Cogentrix Quail Brush Generation Project - Docket Number 11-AFC-3, Clarified NO₂/NO_x Ratio Data Analysis Memo

**APPLICATION FOR CERTIFICATION FOR THE
QUAIL BRUSH GENERATION PROJECT**

Re: Clarified NO₂/NO_x Ratio Data Analysis

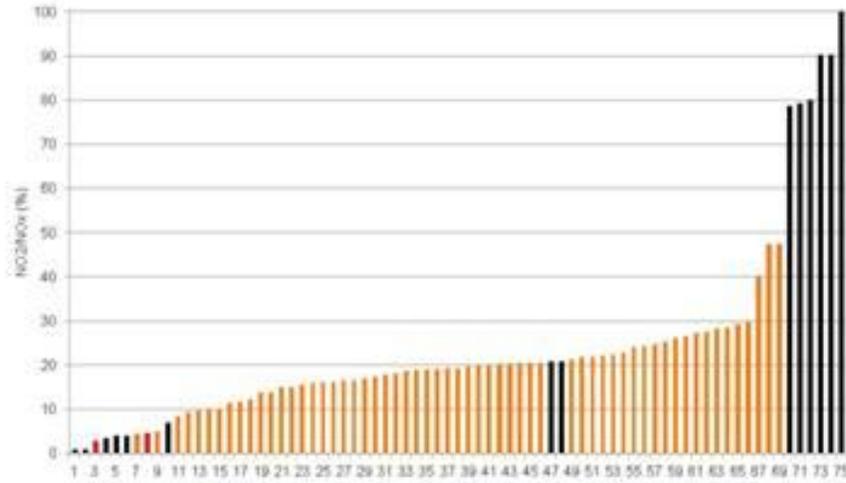
7. Wartsila supplied some preliminary data (late September 2012) on pre-oxidation catalyst NO₂/NO_x ratio data for Wartsila engines at 100% load in the graph below.

Engine family ID key: (orange-SG engines, black-DF engines, red-GD engines):

Wartsila's analysis of this preliminary data is as follows:

All measurements (all engines), pre-catalyst (uncontrolled)

Average - 23.6%

Median - 19.3%

SG Engines only, pre-catalyst (uncontrolled)

Average - 20%

Median - 19.3%

Wartsila notes that the oxidation catalyst used on the SG engines typically reduces NO₂ by approximately 40%. Application of this reduction value to the SG engine pre-catalyst average values results in a NO₂/NO_x ratio value of 12%, which is well below the estimated worst case hour value of 18.5% established in item #6 above.
